ADDENDUM NUMBER: ONE

ISSUED BY: SEPW Architecture Inc.

PROJECT: 25B RANGE RENOVATION

REGINA, SK.

2016/03/01 X:\SEPW PROJECT FILES\2015\23-2015 25B RANGE RCMP DEPOT REGINA\ACAD\WORKING DRAWINGS\AR SHEETS\PLOT FILES\AR01

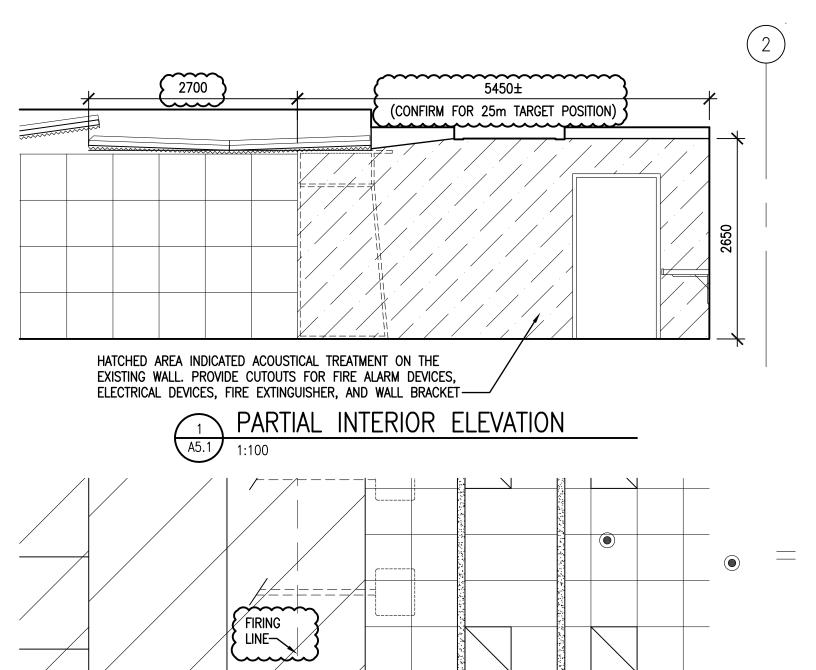
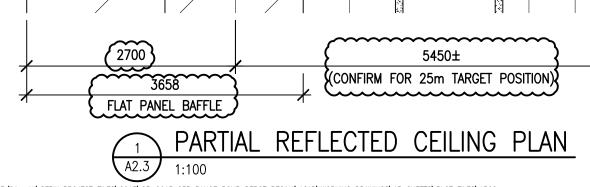
- .1 Reference Drawing 1, Main Floor Plan; REVISION reinstalled shooting booth panels are to be installed at a 2.5° alternating angle as noted on sketch AR01 accompanying this addendum. The front edge (down range side) of the shooting booth is to be installed in its original location, and the back edge of the panel is to be angled. Revise and relocate floor supports and flooring as required. Patch and repair existing areas at removals.

2016/03/01 X:\SEPW PROJECT FILES\2015\23-2015 25B RANGE RCMP DEPOT REGINA\ACAD\WORKING DRAWINGS\AR SHEETS\PLOT FILES\AR02

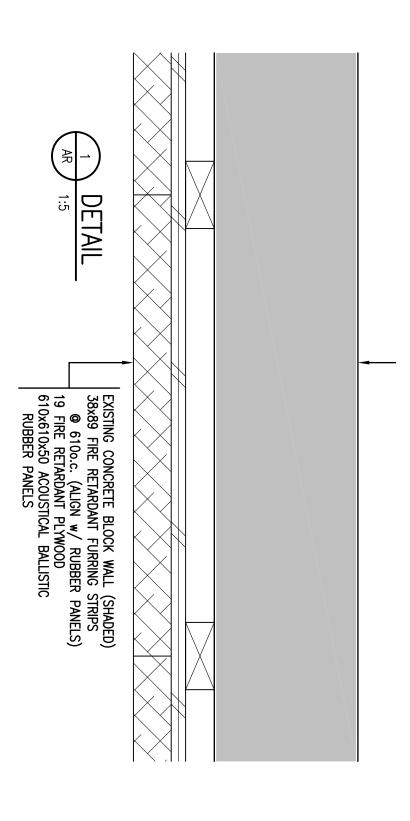
- .1 Reference Drawing 1, Reflected Ceiling Plan; CLARIFICATION location of flat panel baffle assembly in relation to firing line is noted on sketch AR02 accompanying this addendum.
- .2 Reference Drawing 1, Reflected Ceiling Plan; REVISE the installation angle of the flat panel baffle assembly as noted on sketch AR04 accompanying this addendum. Adjust baffle assembly size to maintain the 150mm overlap of the baffles.

.1 Reference Drawing 1, Interior Elevation; location of flat panel baffle assembly in relation to firing line is noted on sketch AR02 accompanying this addendum.

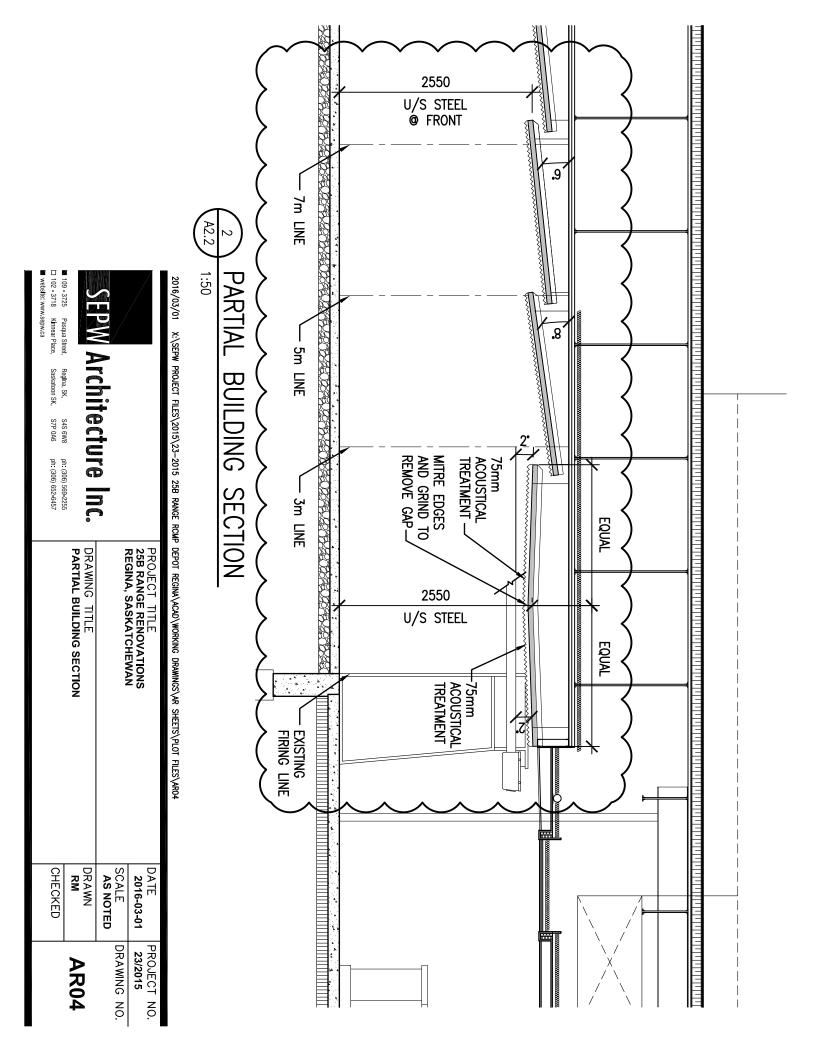
CLARIFICATION: installation assembly of the acoustic ballistic rubber panels are to be revised to create a space behind the rubber panels. Refer to sketch AR03 accompanying this addendum.

- .2 Reference Drawing 1, Main Floor Plan; REVISION, the acoustical ballistic rubber panels are to be mounted onto 19mm fire retardant plywood and 38x89 fire retarding wood furring strips as noted on sketch AR03 accompanying this addendum. Provide a 50mm gap at the bottom of the ballistic rubber panel assembly.

PROJECT NO. 2016-03-01 23/2015 **REGINA, SASKATCHEWAN** SCALE DRAWING NO. **AS NOTED** DRAWING TITLE DRAWN **AR05** WALL SECTION Pasqua Street, CHECKED □ 102 - 3718 Kinnear Place, Saskatoon SK, S7P 0A6 ph: (306) 652-6457 website: www.sepw.ca

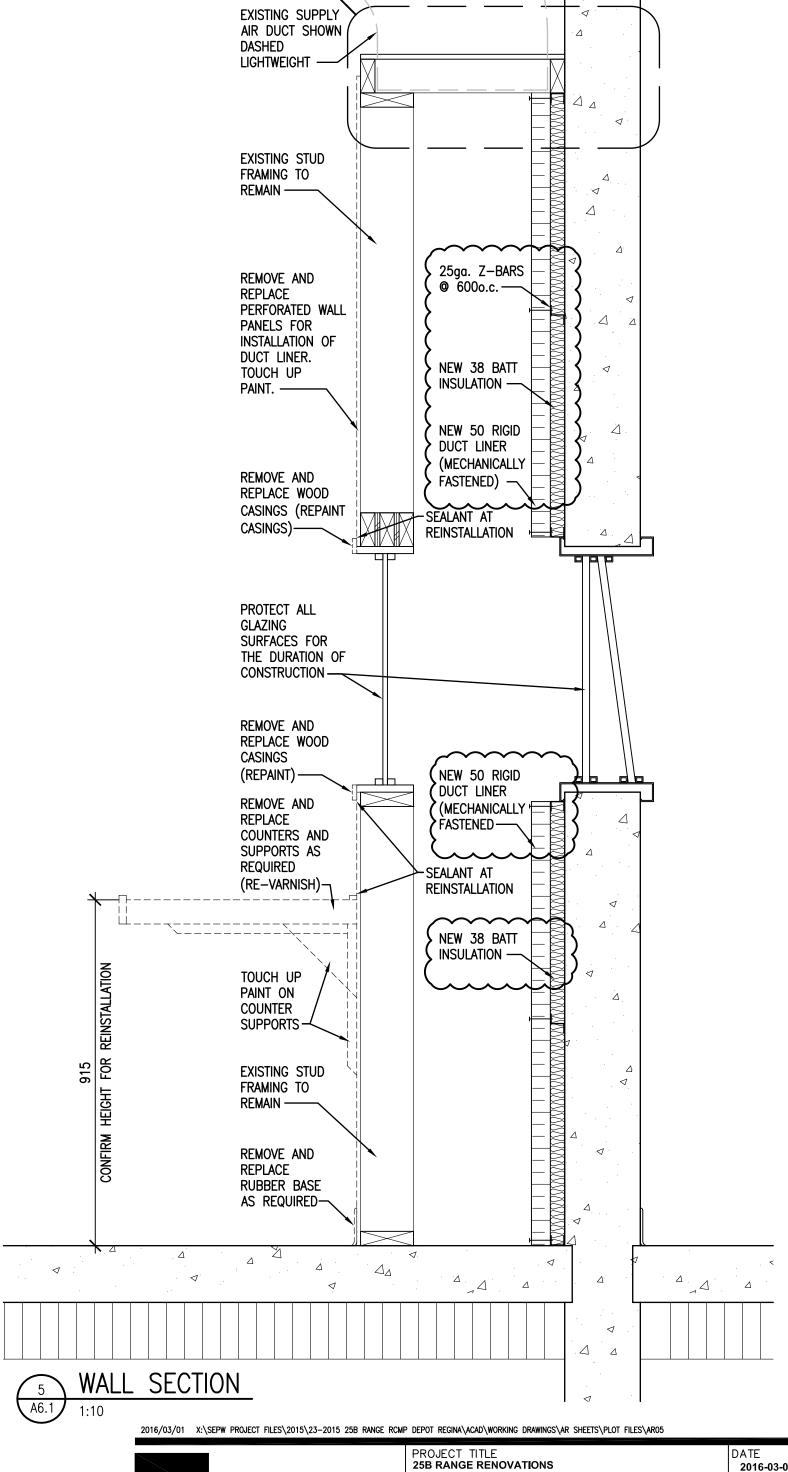
- .1 Reference Drawing 1, Detail; REVISE the acoustical treatment for the flat panel baffle assembly from 50mm to 75mm. Refer to sketch AR04 accompanying this addendum.
- .2 Reference Drawing 5, Wall Section; ADD 38mm batt insulation behind the 50mm duct liner insulation in the air plenum. Support the duct liner insulation with 25ga z-bars spaced at 600mm on centre. Mechanically fasten the duct liner to the z-bars. Refer to sketch AR05 accompanying this addendum.
